SSD6724 – Mixed Use Student Accommodation Development at 60-78 Regent Street, Redfern

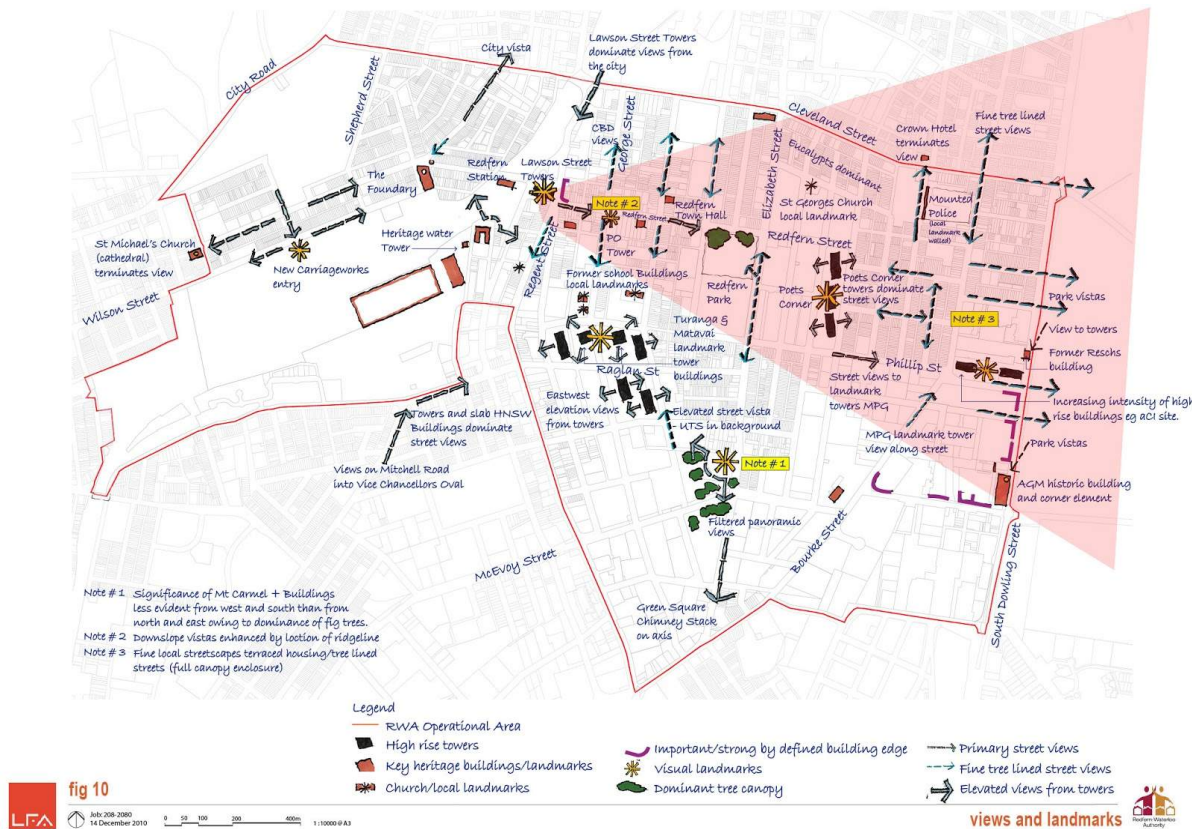
This has a few key issues. As was evident in the original submission and throughout these responses, JBA and Iglu show utter contempt for the realities of the 157 Redfern St site. By saying all views are limited by the use of solid balustrades indicates they have not even bothered to accurately assess the building. This attached picture shows that in fact solid balustrades make up less than 30% of all balconies. So I see no basis in the claim that is a major concern.

Secondly, the Redfern-Waterloo authority seems to put much more value in the easterly view aspect then JBA. As you can see by the red overlay, the eastern aspect encompass many visual landmarks, heritage significant sites and primary street views.

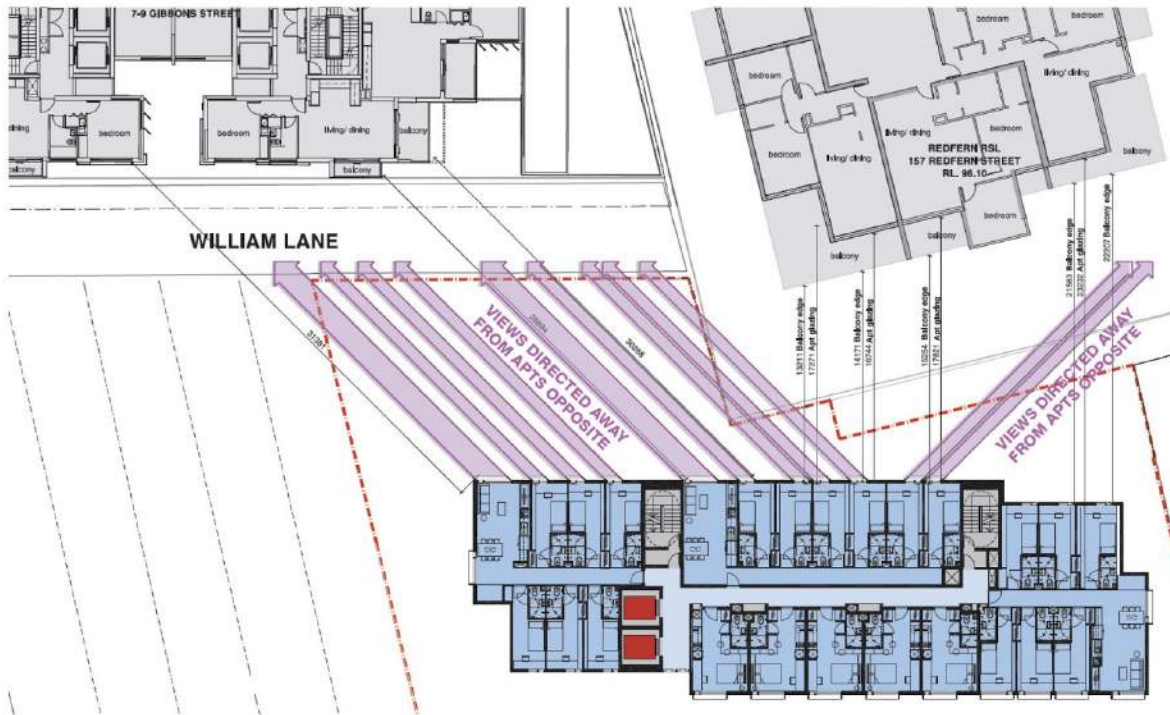
The only solution to the most major issue, privacy, is woefully inadequate. Adding a 30cm angled extension to the window will do nothing to lessen the invasion into neighbouring apartments. This above diagram assumes a person would only ever angle themselves at 45 degree to their window, and apparently be unable to look straight ahead.
